MIL-C-70584B (AR)
AMENDMENT 2
28 October 1992
SUPERSEDING
AMENDMENT 1
09 August 1991

MILITARY SPECIFICATION

CIRCUIT BOARD, CONTROL AND SYNCHRONIZER,
VOLTAGE CONVERTER (PIVADS): 9397382

Figure 1. Burn-in Temperature Versus Time Diagram

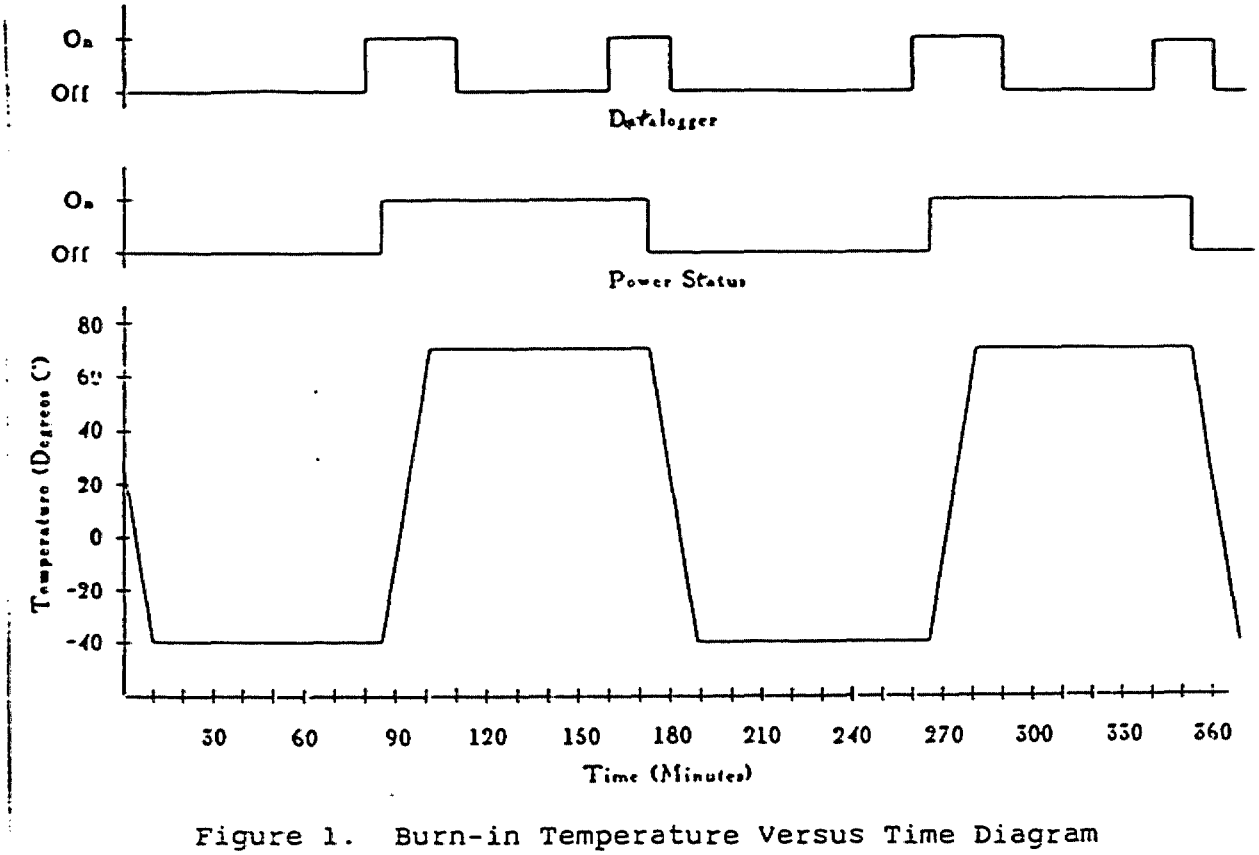
Figure 1: Delete in its entirety and substitute the following:
